Executive Director's Recommendation

Commission Meeting: November 7, 2019

PROJECT Second Division Memorial Modification President's Park Constitution Avenue, NW & 17th Street, NW Washington, DC	NCPC FILE NUMBER 8120 NCPC MAP FILE NUMBER 1.31(73.10)45017
SUBMITTED BY United States Department of the Interior National Park Service	APPLICANT'S REQUEST Approval of comments on concept plans
REVIEW AUTHORITY Commemorative Works Act per 40 U.S.C. § 8905	PROPOSED ACTION Approve comments on concept plans ACTION ITEM TYPE Staff Presentation

Option A

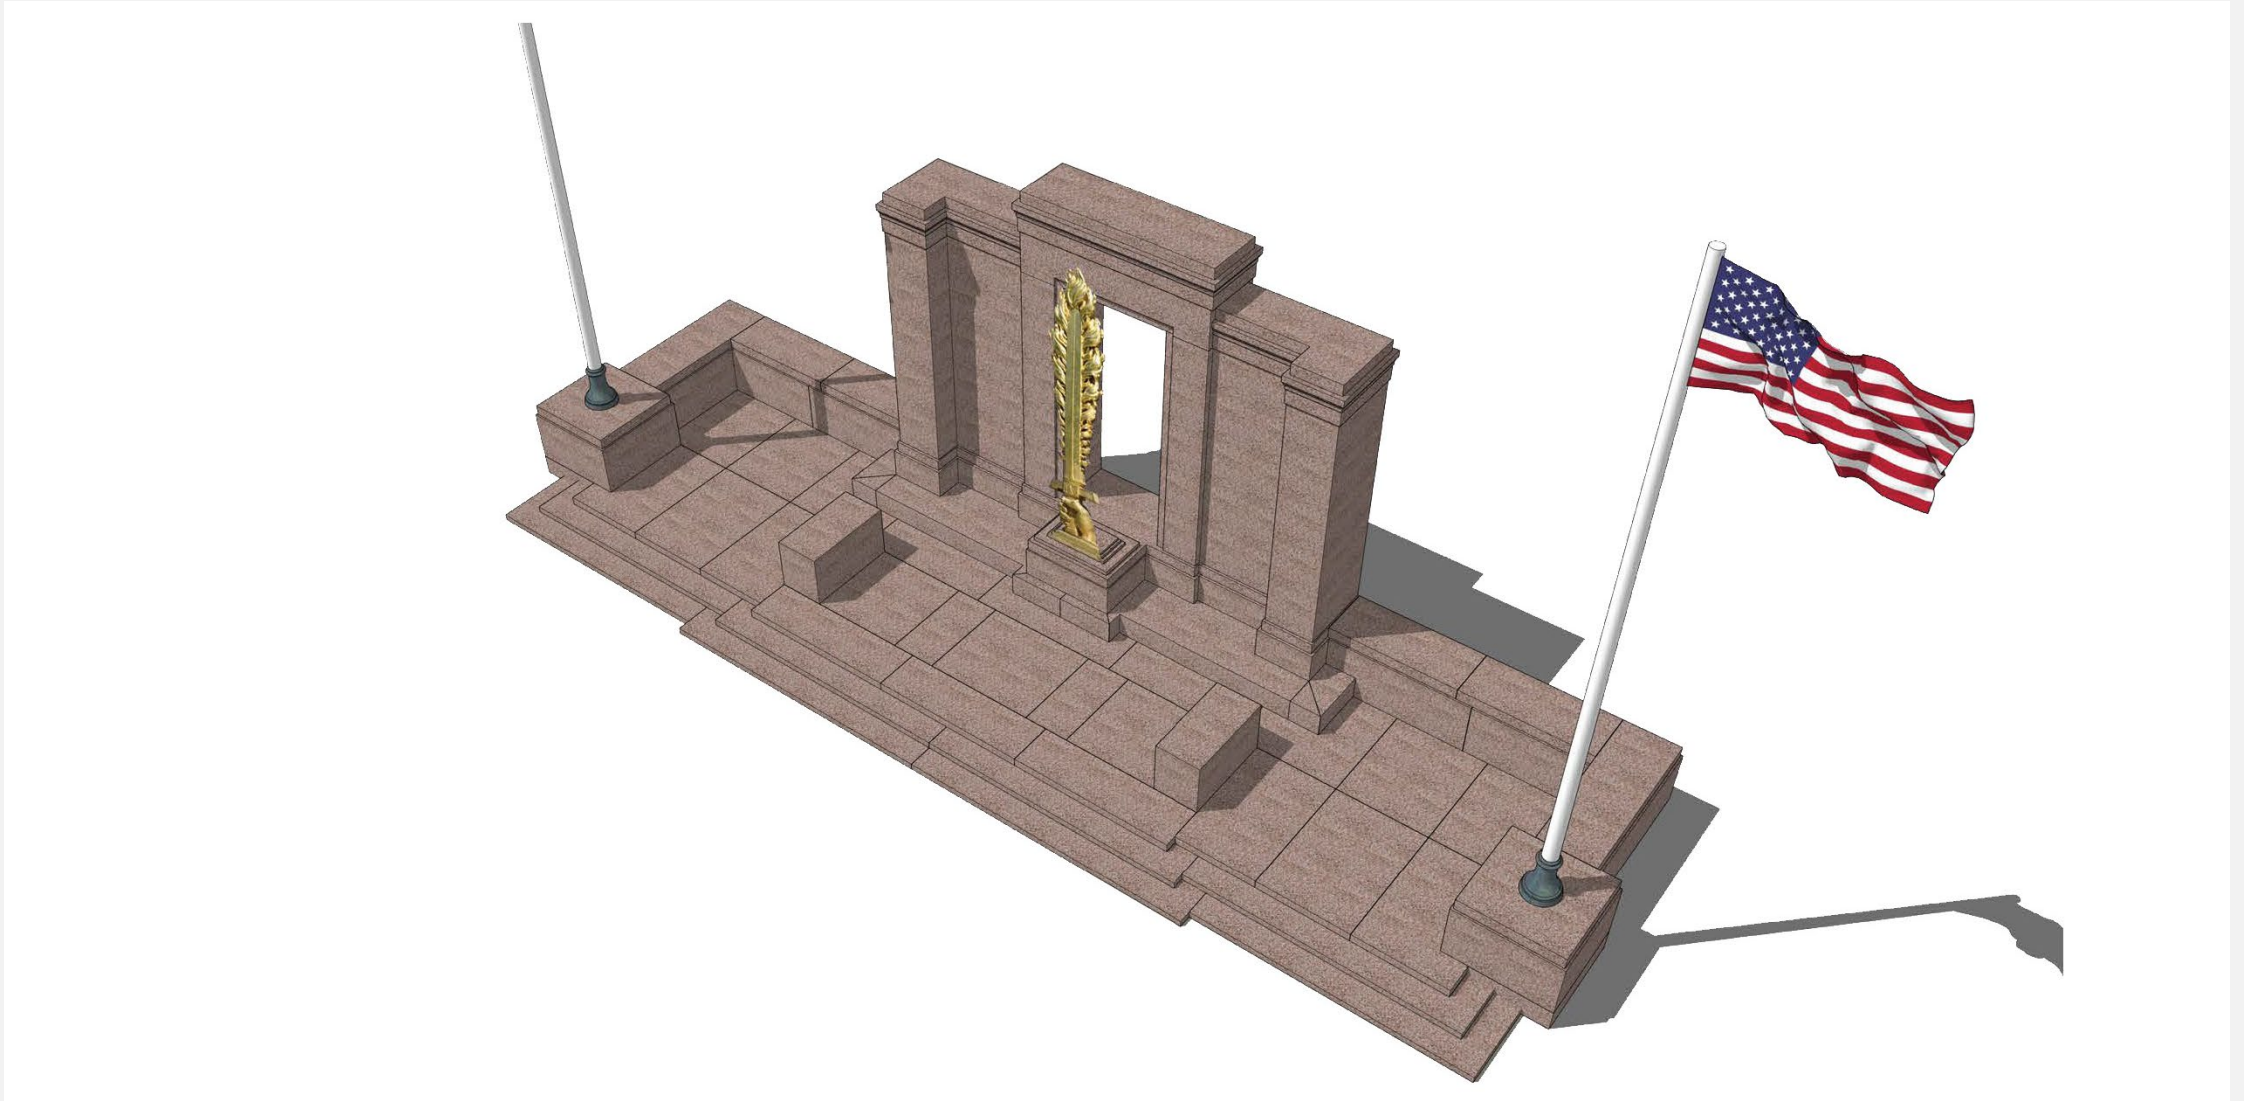
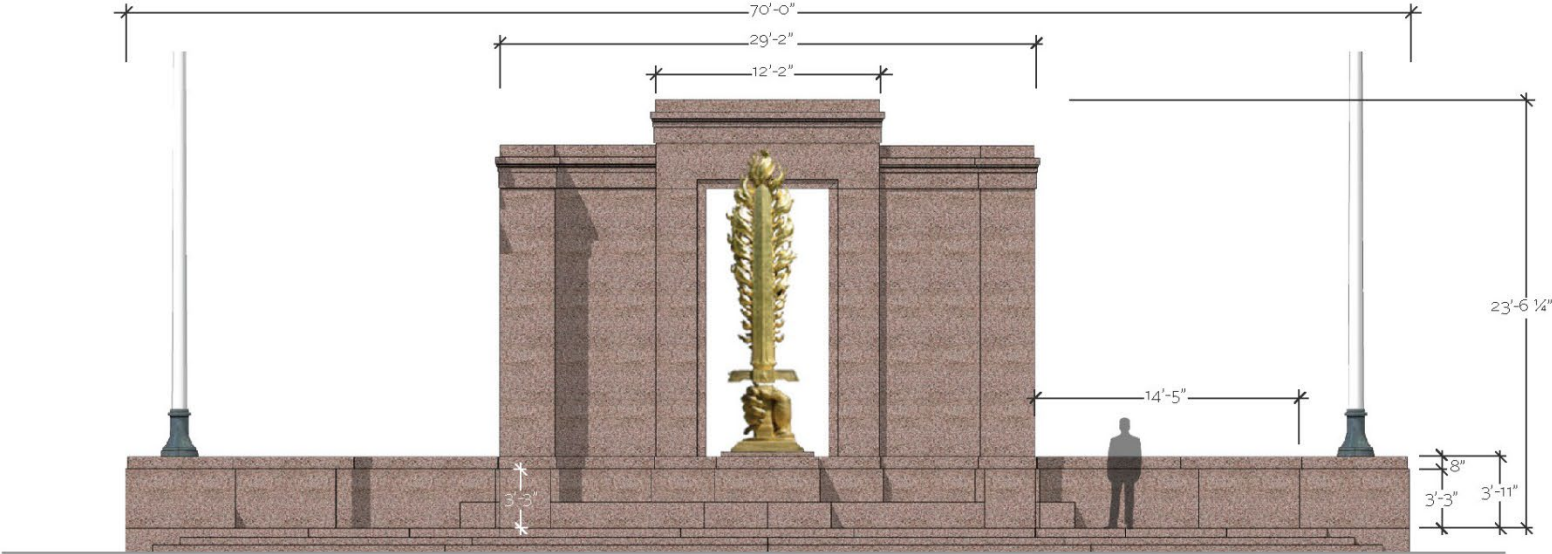
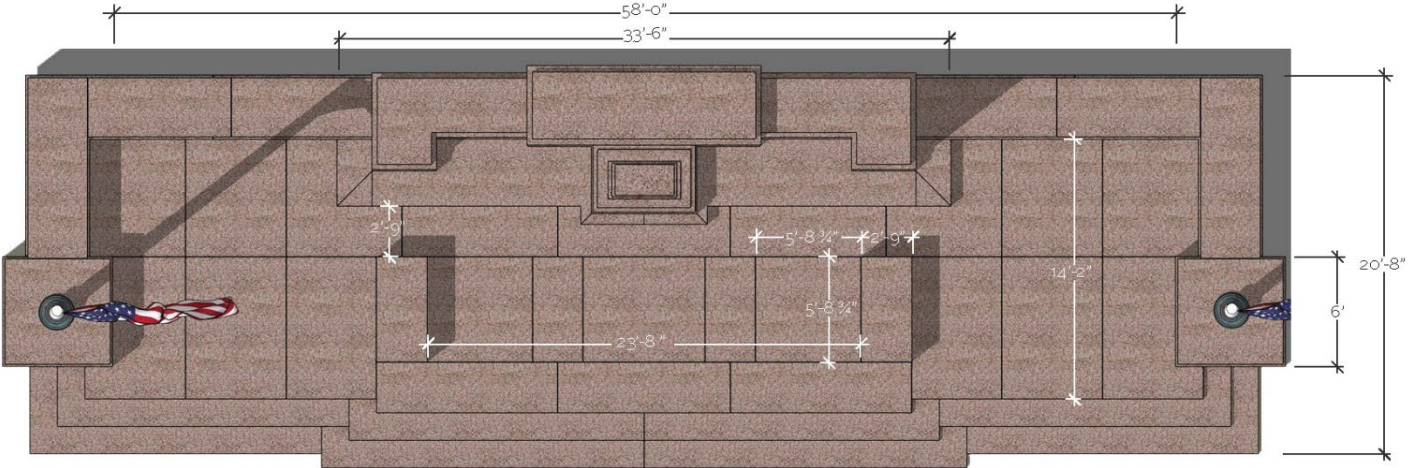
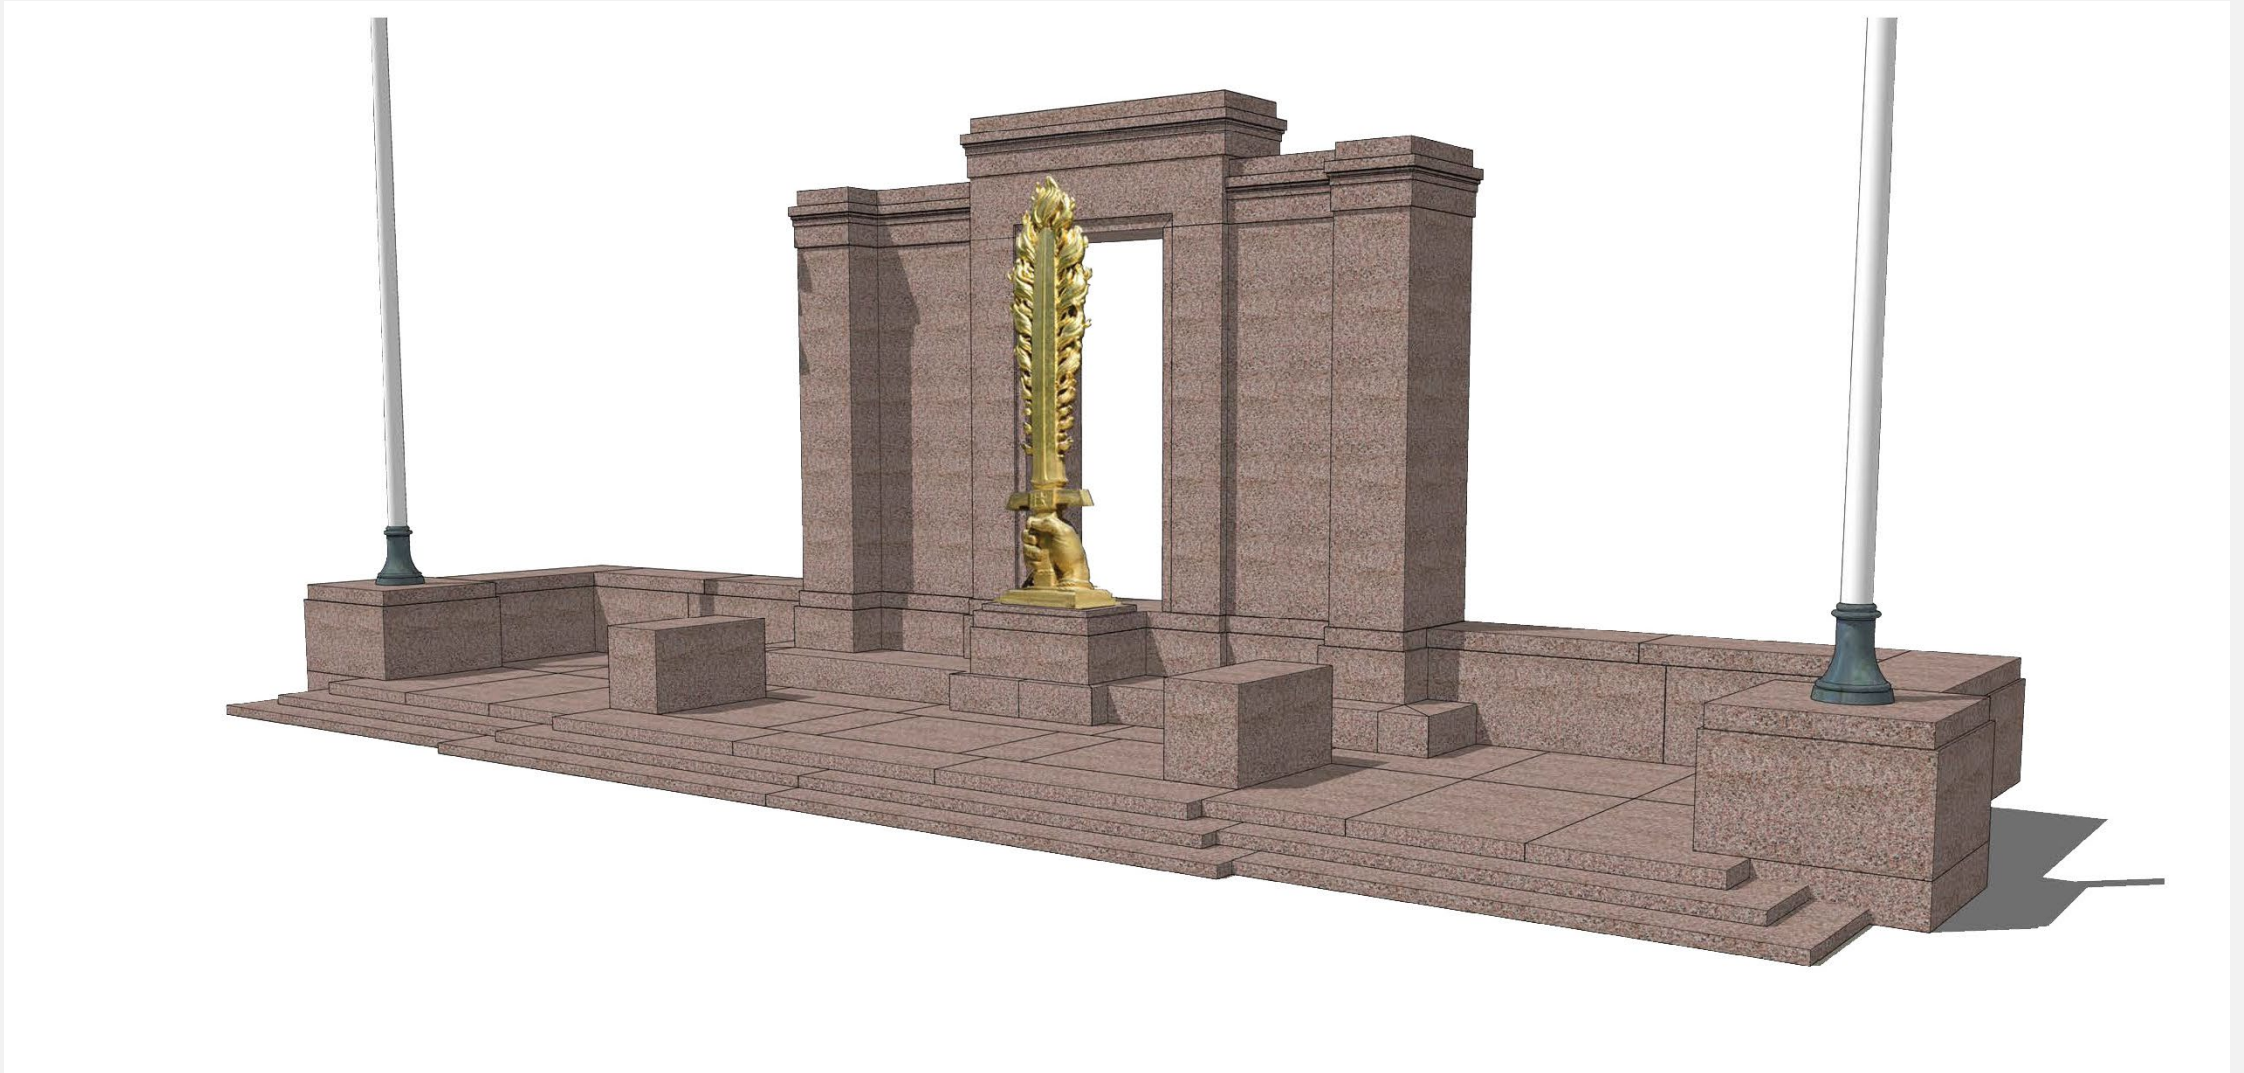
Finds Options A, B, and C do not alter the footprint of the memorial. Each includes the addition of two new stone plinths in varying sizes and locations. However, the locations of the new plinths

create “pinch points” for pedestrian circulation and do not allow sufficient space for gathering within the memorial platform. The original memorial elements would be altered in these options.

Options A, B, and C are similar in that they do not alter the footprint of the memorial. Each includes the addition of two new stone plinths in varying sizes and locations. However, the locations of the new plinths are concerning because they create "pinch points" for pedestrian circulation. The space between the plinths and existing memorial walls measures 2'-9". Typical routes for pedestrian movement should be greater than 3'-0". Further, the introduction of the new plinths into the existing memorial platform does not allow for sufficient space for gathering within the memorial itself.
